**Town of Kittery  
Planning Board Meeting  
September 26, 2019**

**ITEM 2 – 76 Dennett Road – Site Preliminary Plan Review**

**Staff Review**

FRONT LANDSCAPING PLAN  
**C17**  
PROJECT NO. 569200  
SHEET 17 OF 25

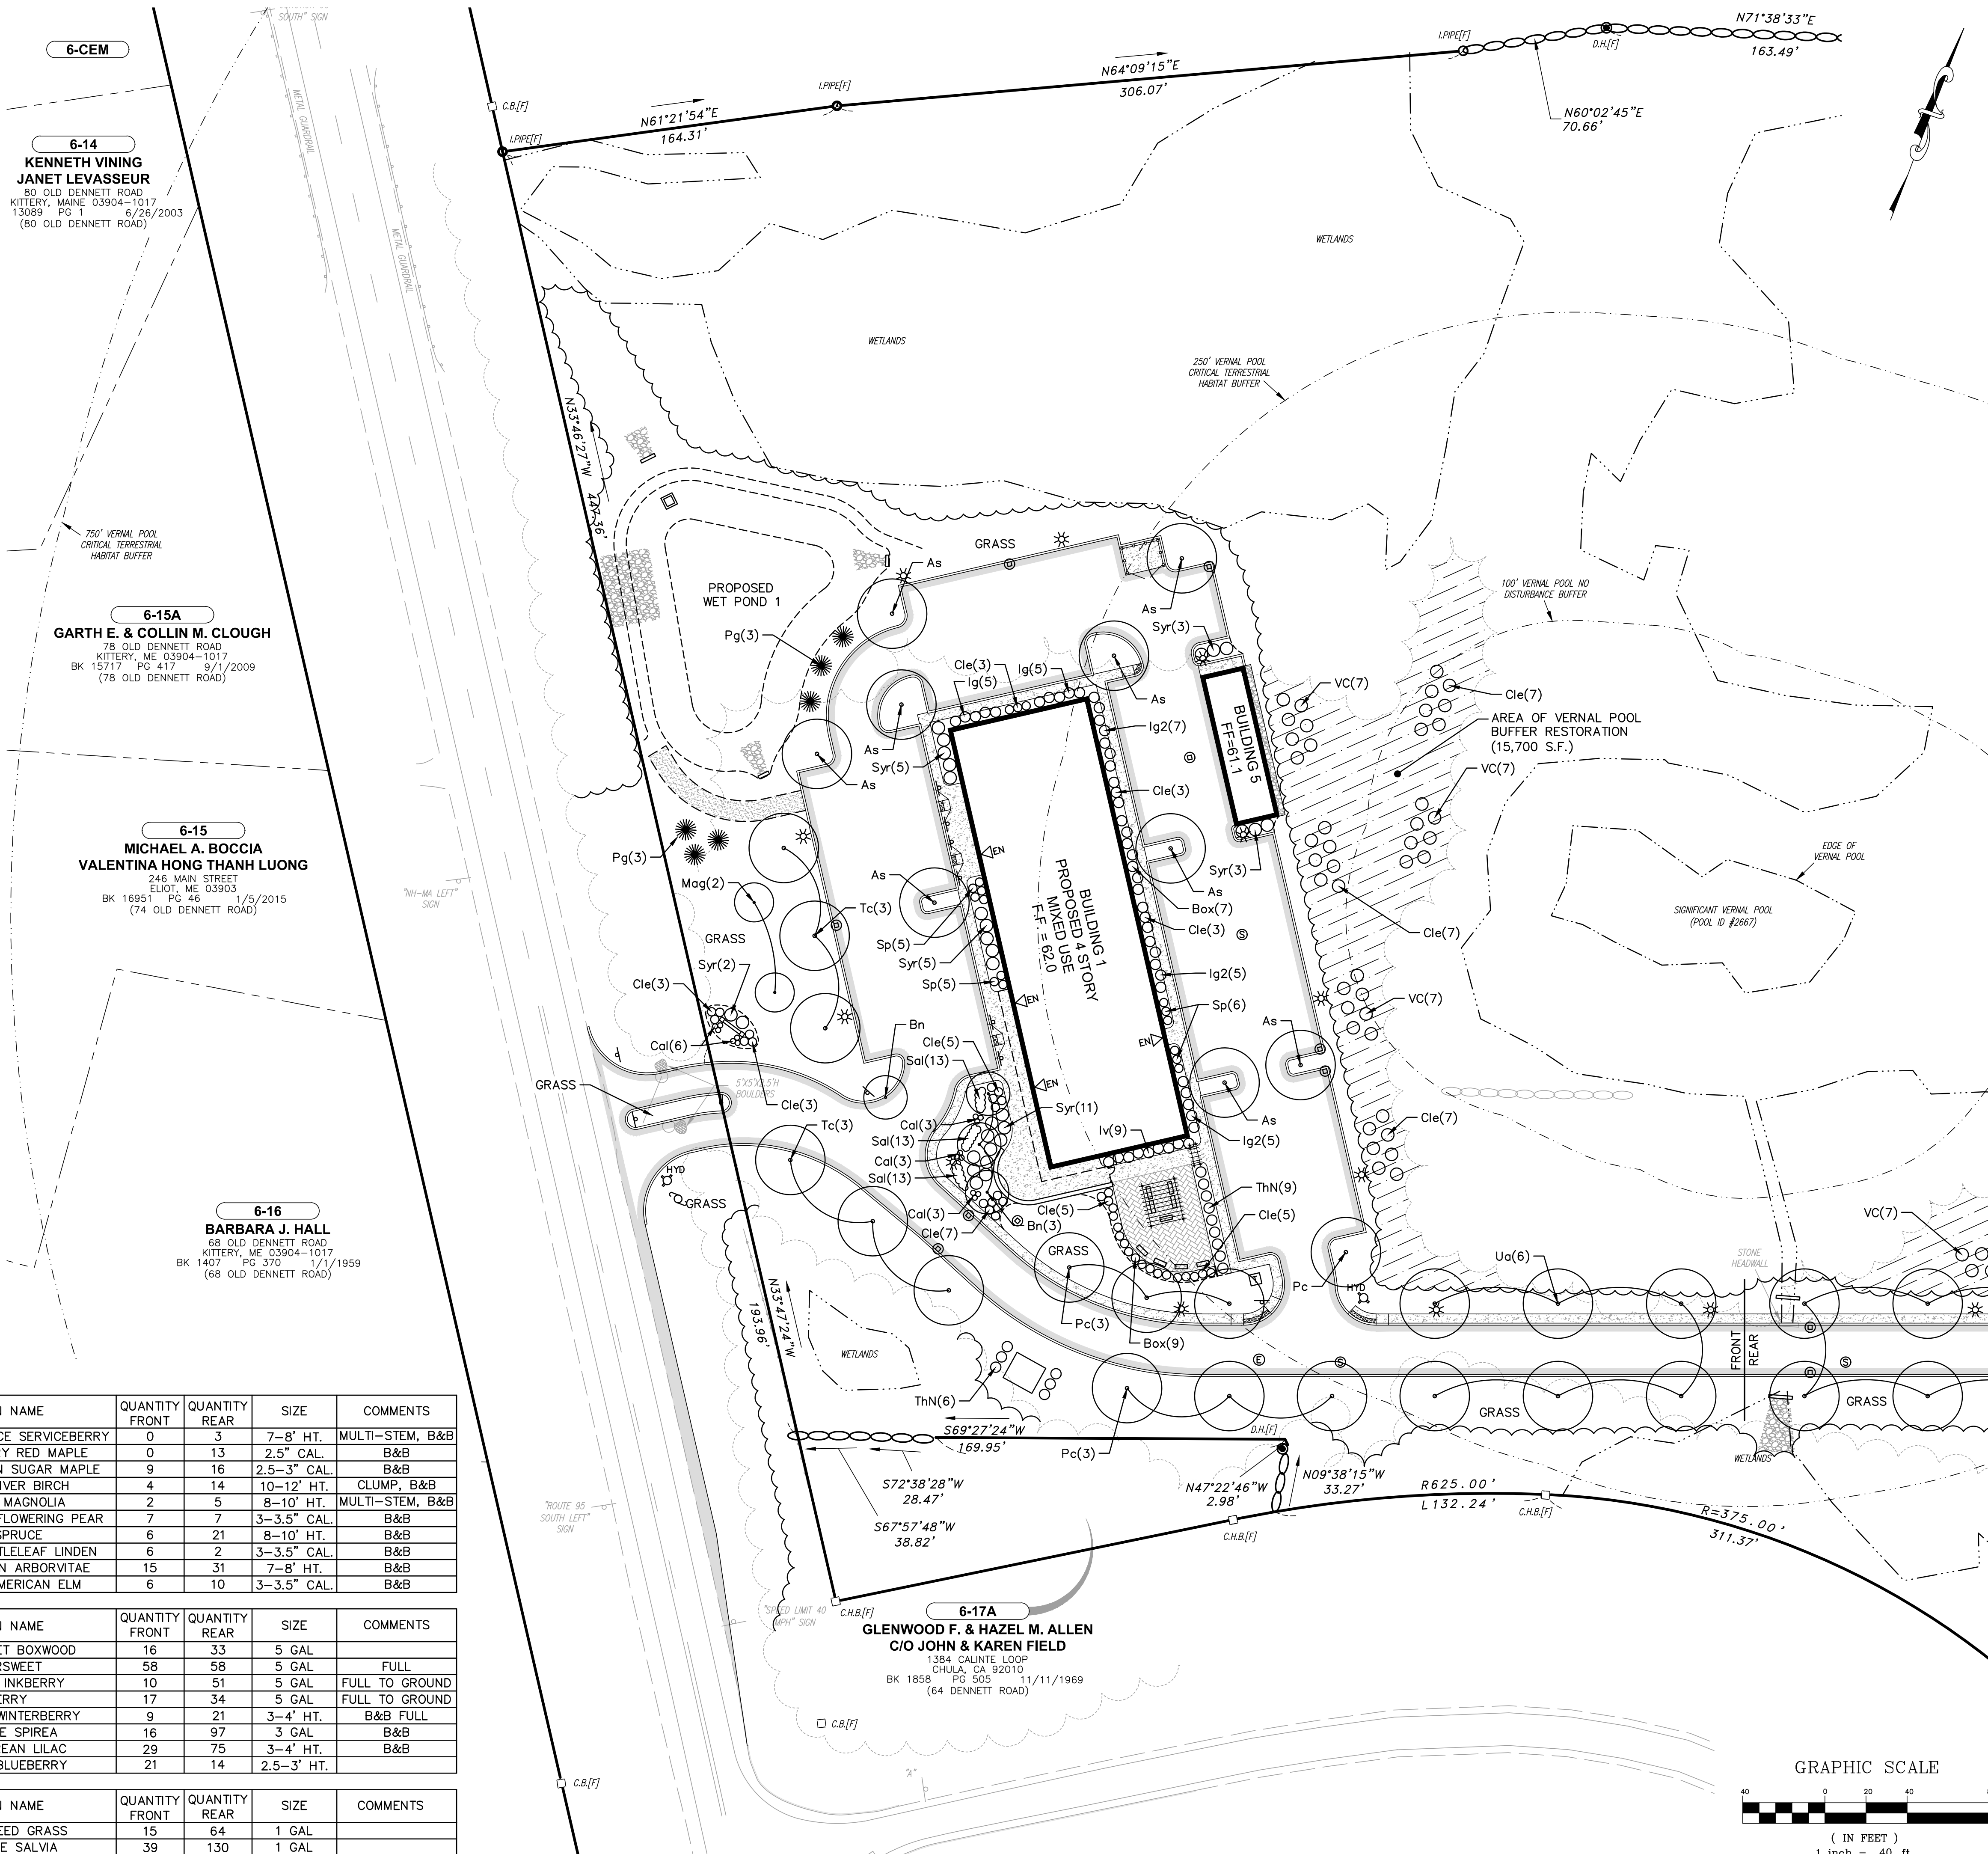
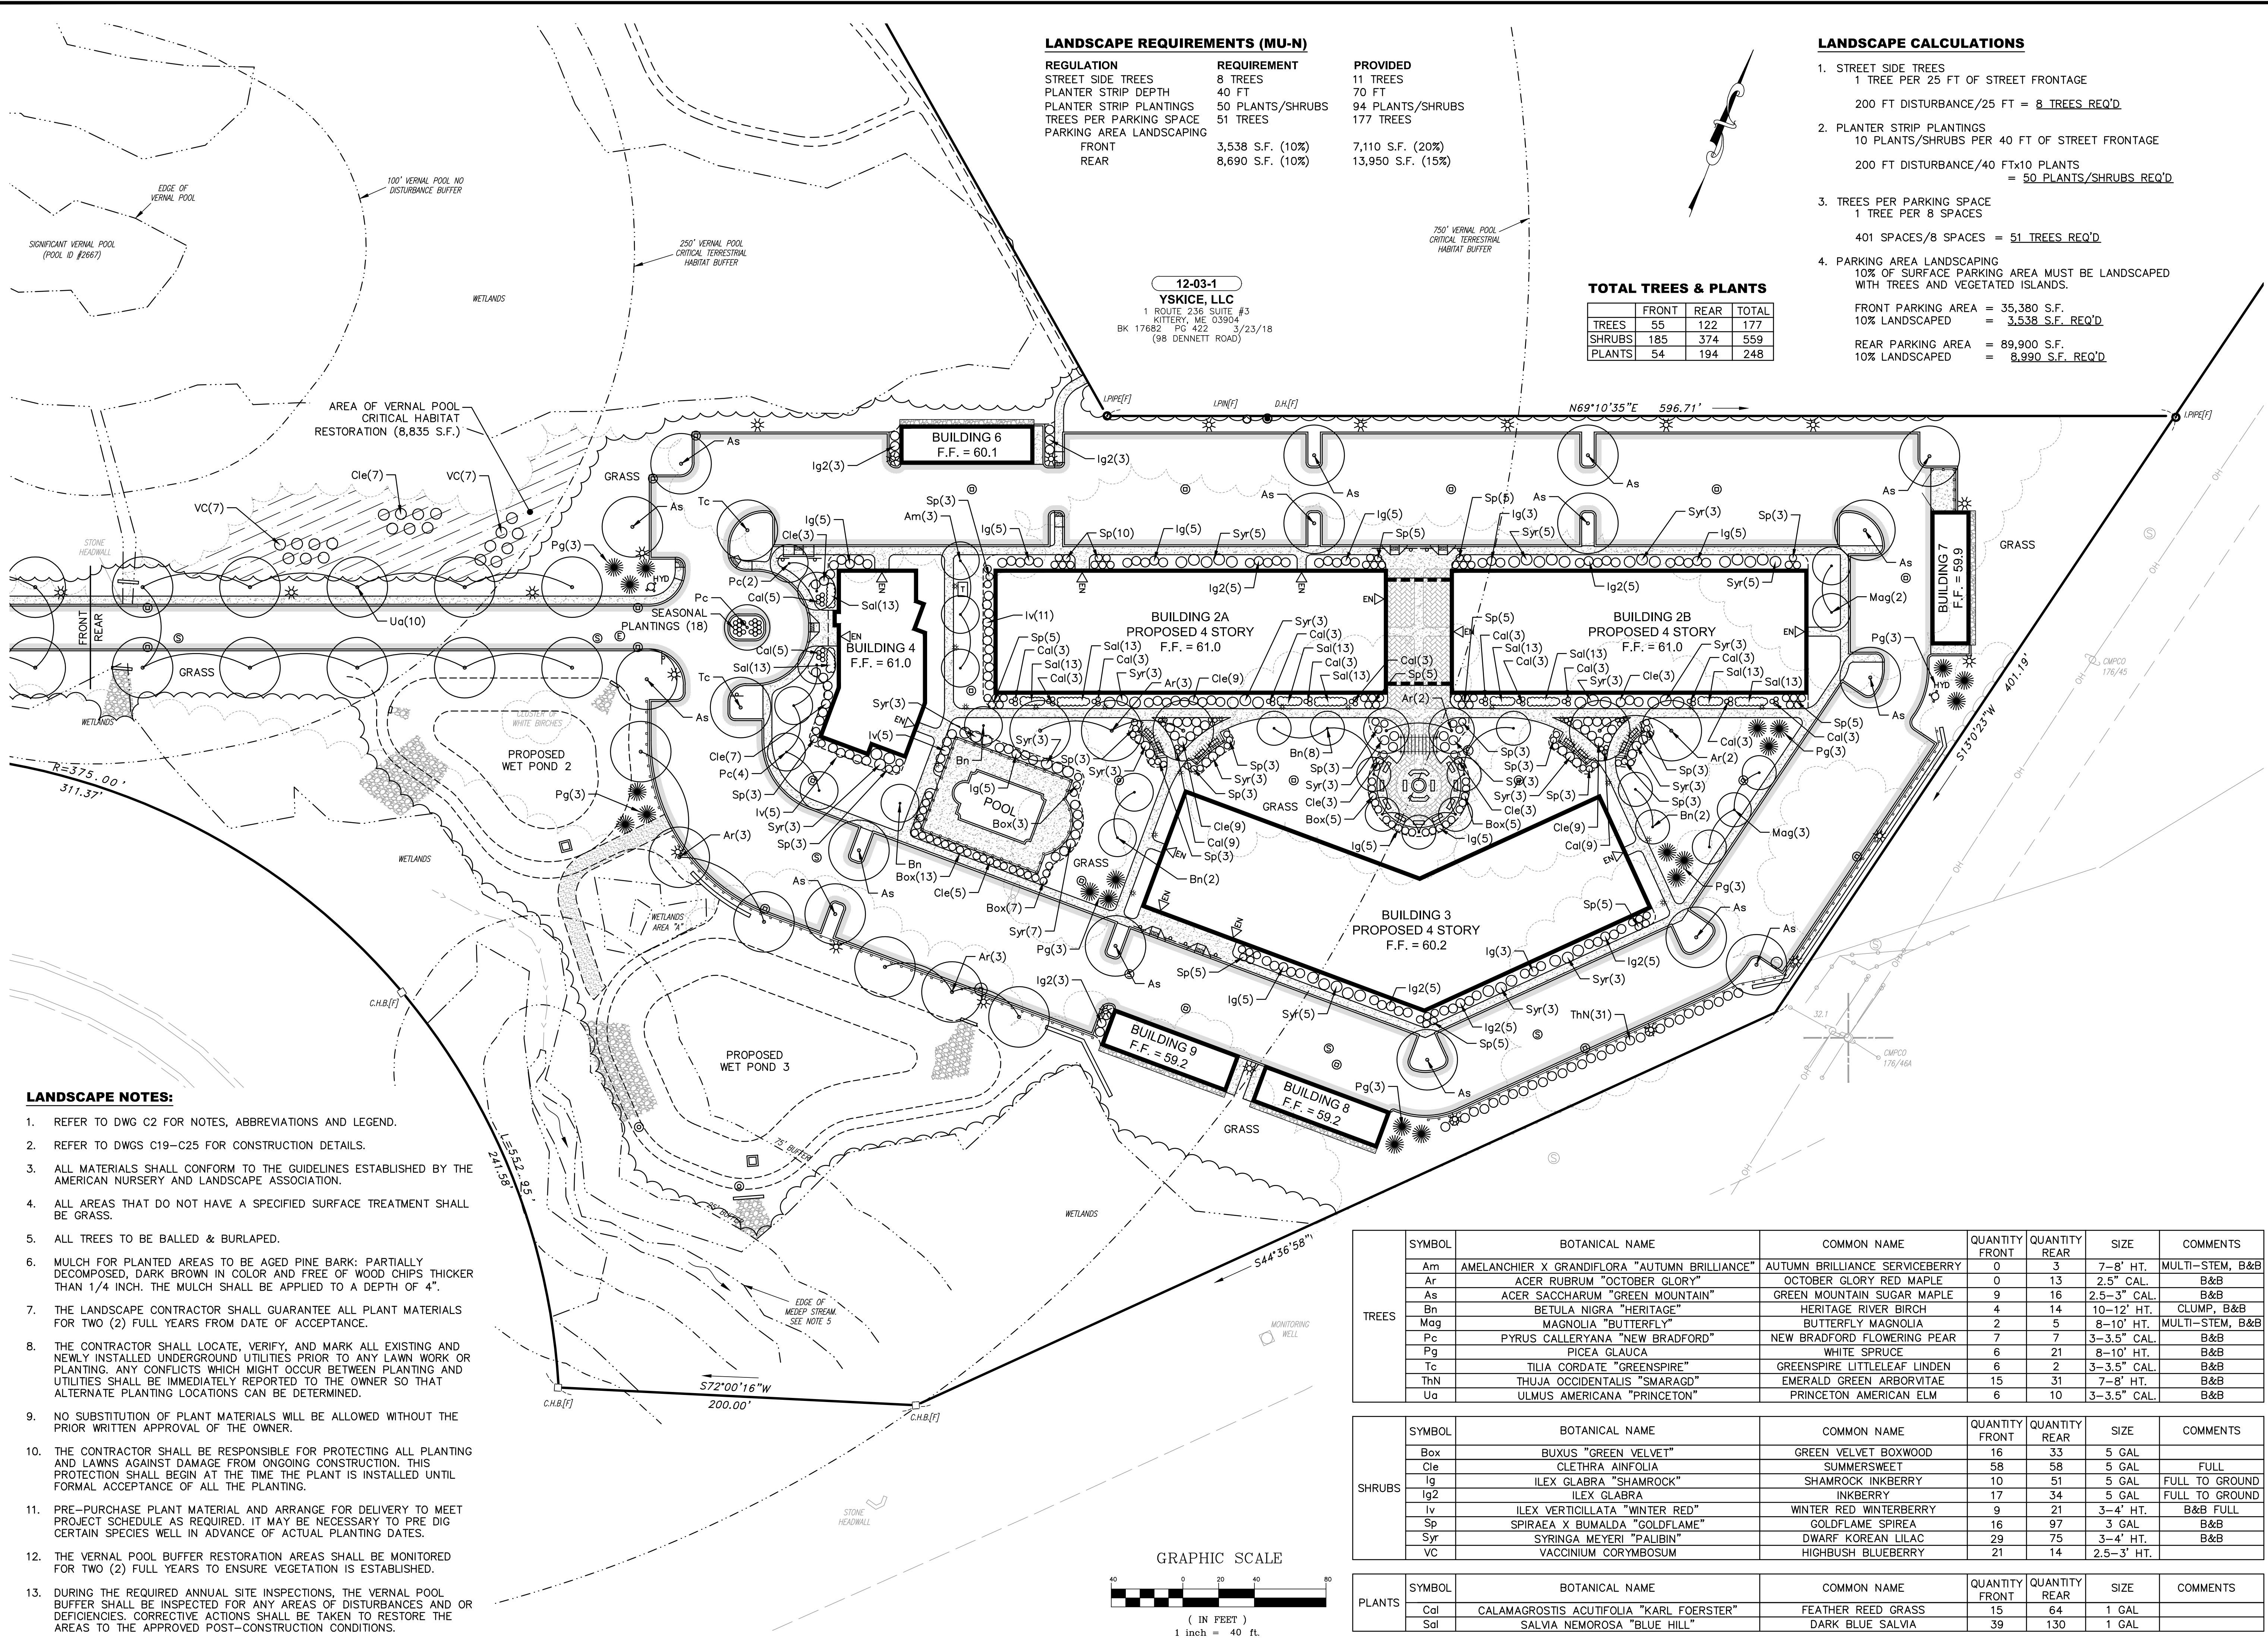
4. The landscaping, screening and buffering details are provided on sheets C17 and C18. Per 16.3.2.10.F (9) (a) a landscape plan prepared by a registered landscape architect is a submission requirement. However, a landscape plan done by other design professionals may be allowed at the Planning Board's discretion. The proposed development will be generously landscaped and appears to meet the requirements of the MU-N zone. CMA Engineers in their initial review of the preliminary plans noted that the ordinance requires that a minimum of 10% of surface parking areas be landscaped with trees and vegetated islands. CMA questioned whether this standard was being met. In reviewing the landscaping plans, the parking lot bump-outs do include one tree and grass plantings. The applicant has indicated that shrubbery was avoided in these areas because of salting and sanding of the parking areas that could damage the plantings. Figures need to be provided for these landscaped areas to determine whether they comply with the 10% requirement and revisions made to the plans if the standard is not met. According to the landscape calculations shown on Sheets C17 & 18 they are providing over triple the number of trees per parking spaces under the Ordinance requirement. The applicant has satisfactorily addressed this requirement by updating the landscaping plans to include calculations that show compliance with 10% requirement. An additional landscaped

island with a tree and vegetation has been added in front of Building 1. Update: A recommended condition of approval that the Town engage a third party review by a registered landscape architect of the proposed landscaping plan is included.

- The plans were revised to provide two street connections separated by a 10-foot-wide, 50-foot-long island with mountable sloped granite curbing. See waiver request form and memo for additional information.
- A detail for the curbed island was added to the detail sheets.
- A right hand turn lane into the property was added to Dennett Road.
- The pavement thickness for the site access drive was increased to 3.5" to match design standards for a Primary Collector.
- The internal sidewalk network was extended to the property line for a potential future connection near Building 2A and the nature trail.
- An additional crosswalk and tip-down ramp was added to accommodate the sidewalk extension.
- The water main through the site was increased to a 12" pipe.
- Note #7 on the Landscape Plans was revised to guarantee all plant materials for two (2) full years per design standards

- Note #12 on the Landscape Plans was revised to provide two (2) years of vernal pool buffer establishment monitoring.
- Note #13 was added to the Landscape Plans: *“During the required annual site inspections, the vernal pool buffer shall be inspected for any areas of disturbances and or deficiencies. Corrective actions shall be taken to restore the areas to the approved post-construction conditions.”*
- Vernal pool buffer sign/marker locations were added to the site plans. The signs/markers shall read “Vernal Pool Buffer, No Disturbance”
